# LSD Averill Addendum No. 1

## Narrative of Changes

<b>Project Name:</b>	Averill Elementary Renovation SO-1847	<b>Date:</b>	December 4, 2025
<b>Project Location:</b>	3201 Averill Dr Lansing, MI 48911	<b>Architect's Project #:</b>	25013568A
<b>Owner/Client:</b>	Lansing School District	<b>Attention:</b>	David Beckering
<b>Issued to:</b>	Beckering Construction	<b>Email:</b>	djb@beckering.com
<b>City/State:</b>	Grand Rapids, MI	<b>Zip:</b>	49548

Sketch "A"

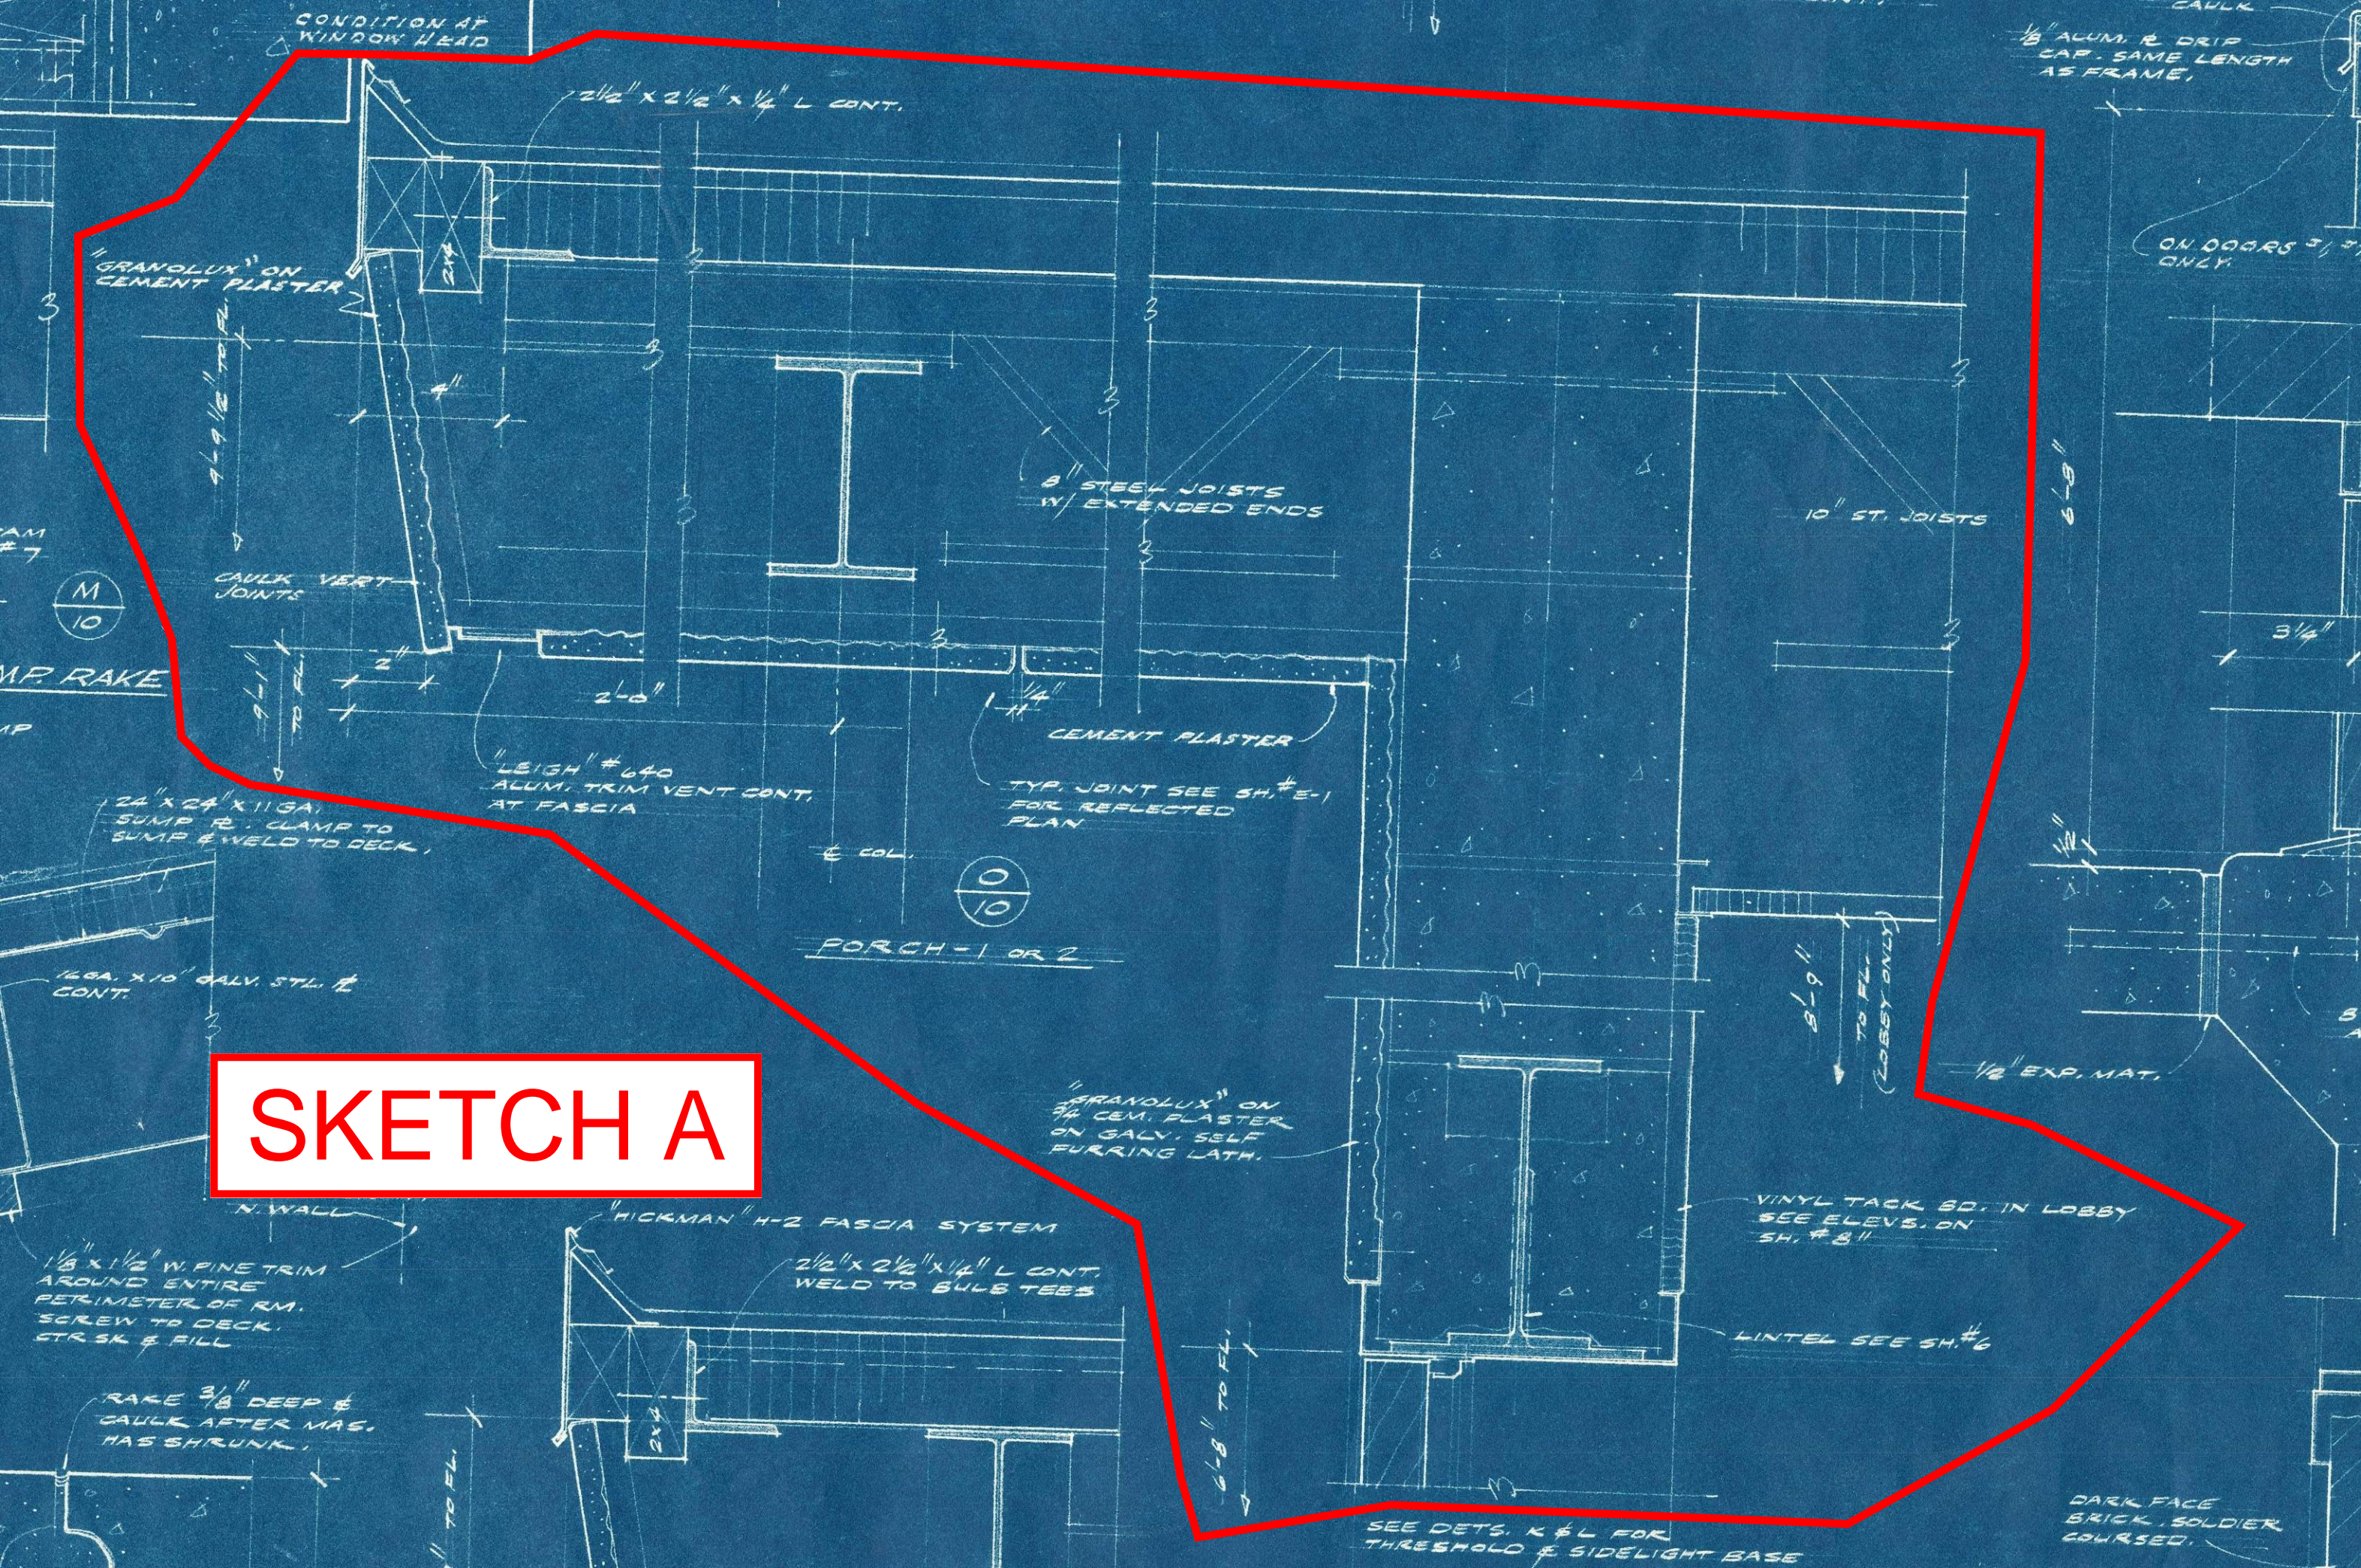
- In issued Clarification 2, it states that new thermostats are to be supplied by Division 'G' this is a mistake. The existing thermostats are to be relocated by electrical contractor. There are no new thermostats.
- See sketch "A" for snippet of 1963 existing drawings. It is unknown what the existing supports are for the existing plaster ceiling in the vestibule. We suggest that a small piece of the existing ceiling be removed prior to full removal for better understanding of existing conditions. For bidding purposes, assume that the plaster board is attached to metal furring that is attached to the steel joists.

AD010

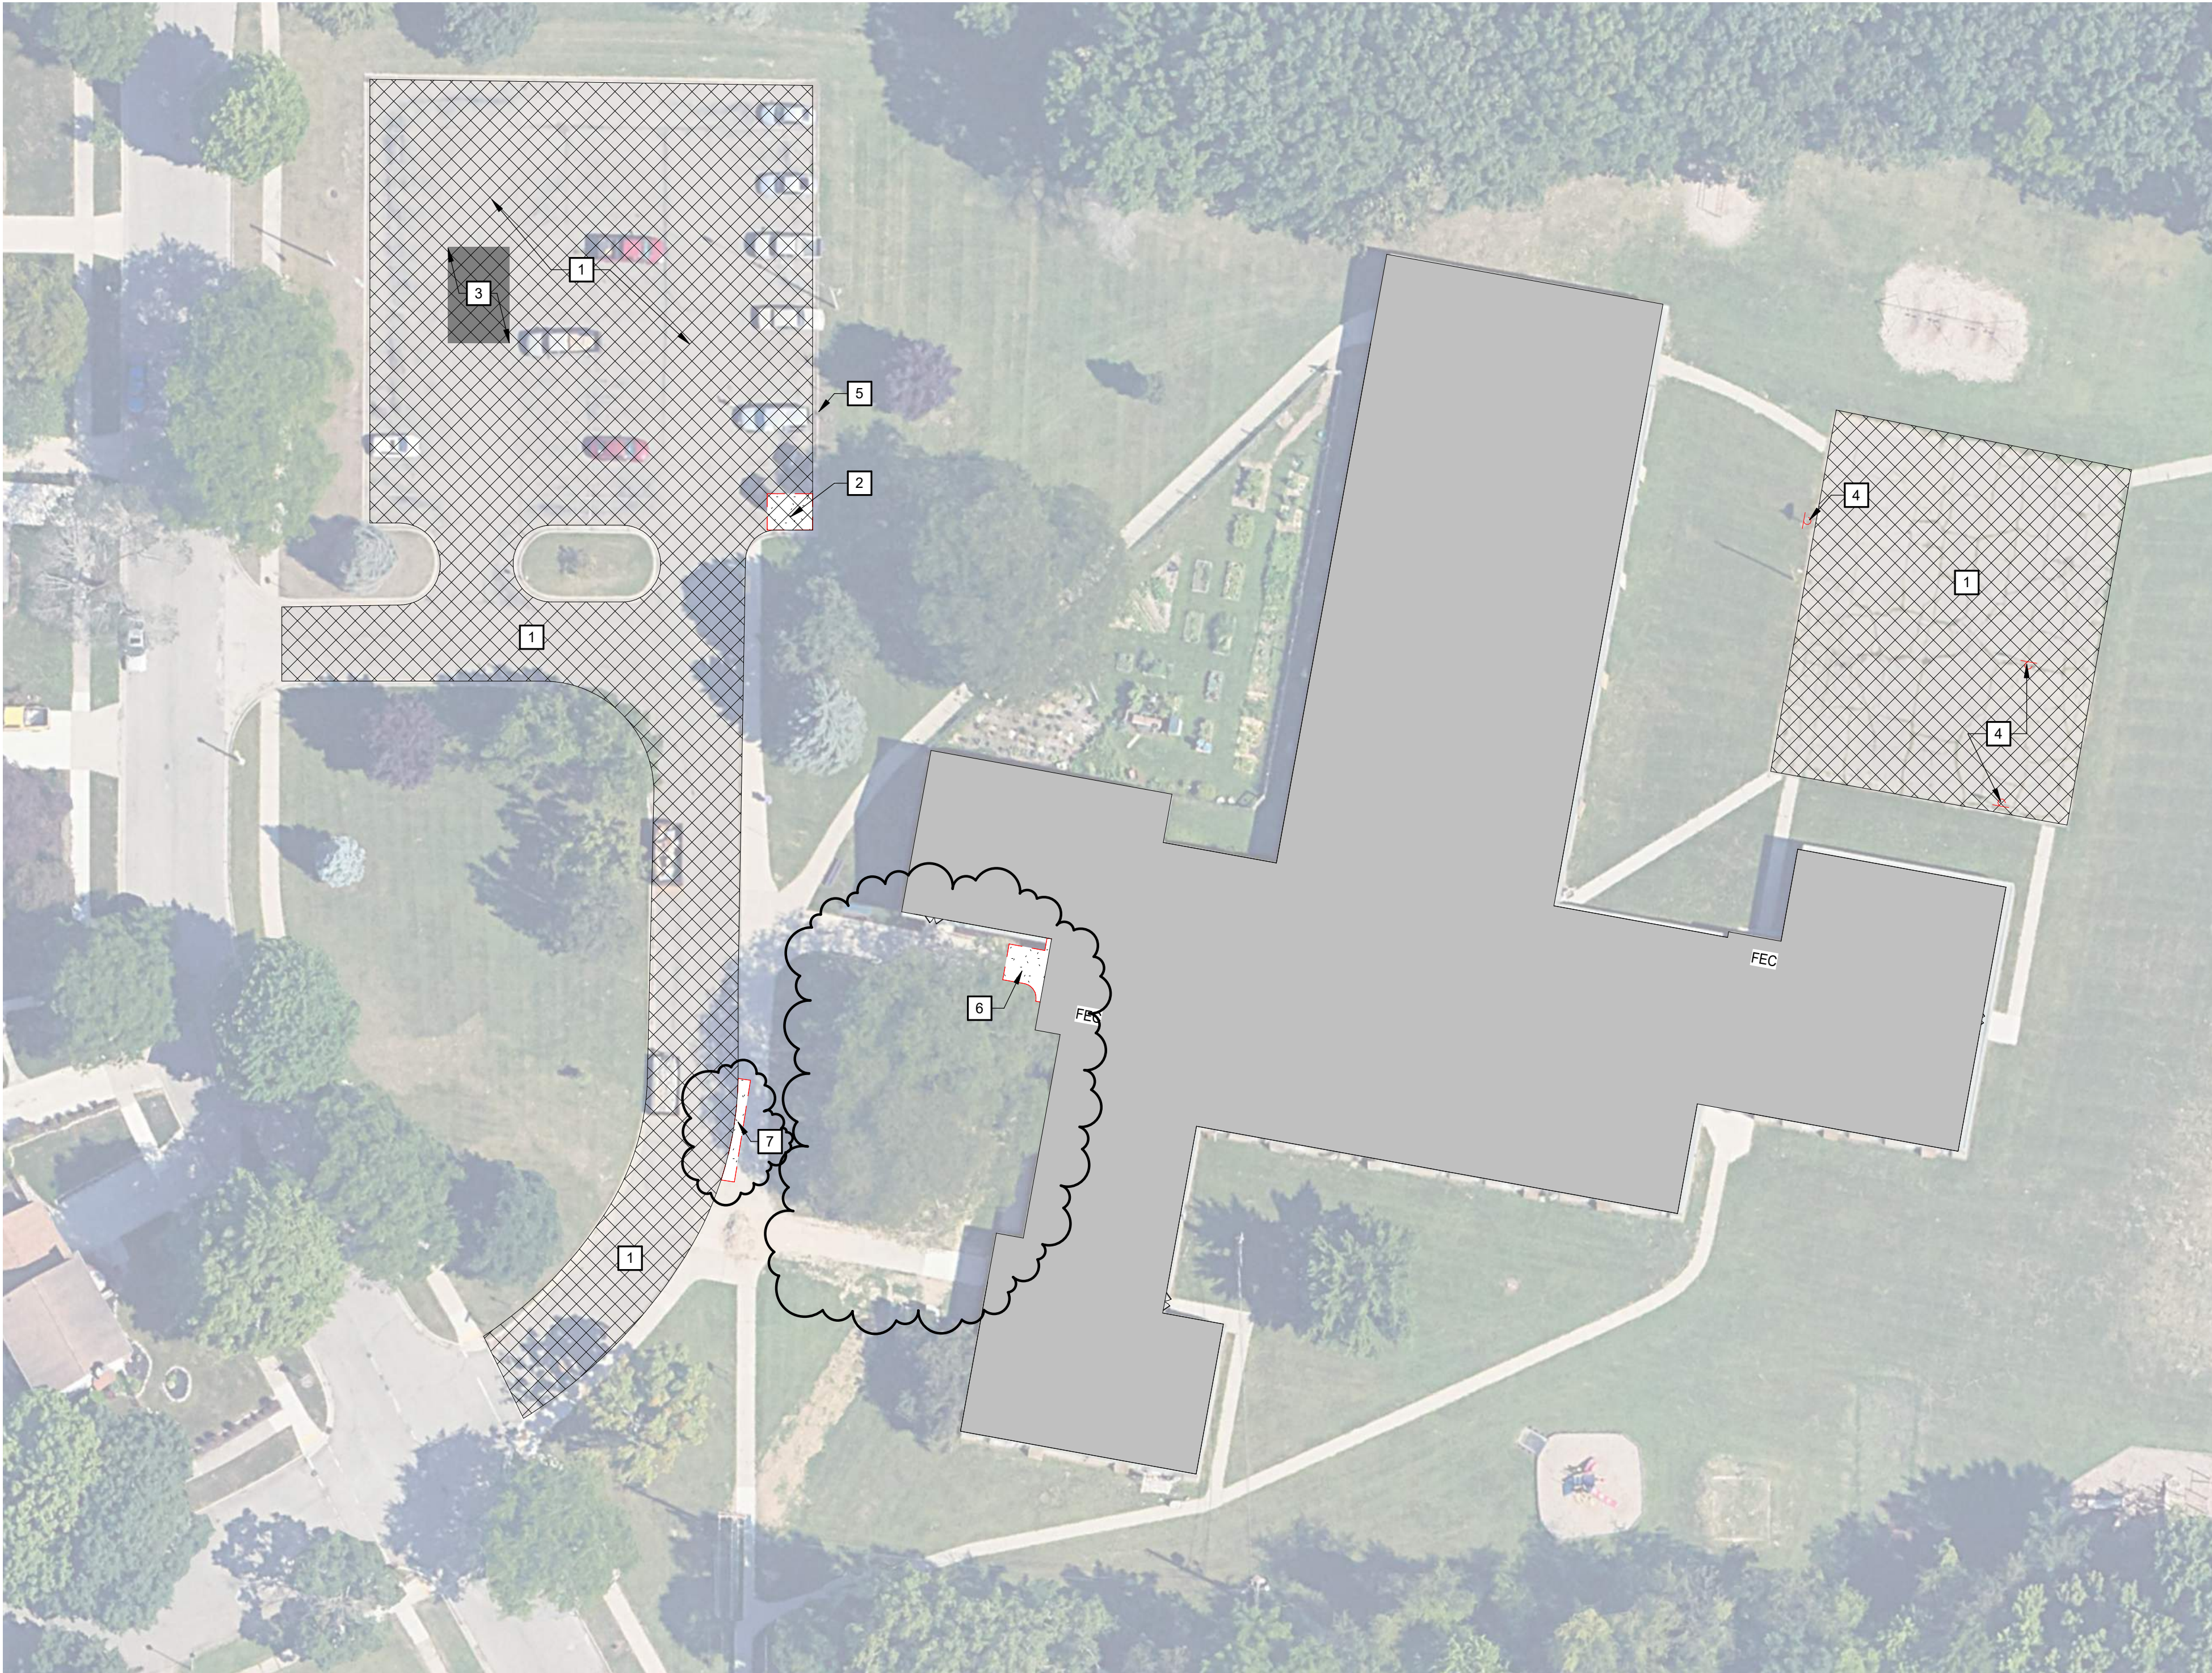
- Revised concrete hatching, refer to bubbled area on sheet AD010.
- Added additional concrete removal at sidewalk refer to bubbled area on sheet AD010 and keynote 7.
- Added additional concrete at sidewalk refer to bubbled area on sheet A010 and keynote 13.
- Composite fencing to be Trex Horizons, color woodland brown. Installed horizontally. Refer to sheet A011.
- Added keynote 20 to provide wood blocking for future upper cabinets in wall. See bubbled areas on sheet A101.
- Added specification for CPT-1 on sheet A141.
- Added dimensions to section 4/A301 for clarification.
- Added note 11 to include demo of existing receptacles on columns to be removed. Refer to sheet ED100.

REMOVE PORTION OF EXISTING TURN DOWN CONCRETE SIDEWALK AND SUBGRADE. PREP FOR NEW SUBGRADE AND CONCRETE. EXISTING CONCRETE SIDEWALK IS SETTLING REMOVE BACK TO NEAREST CONTROL JOINT. APPROXIMATELY 3'-6" x 30'-0".
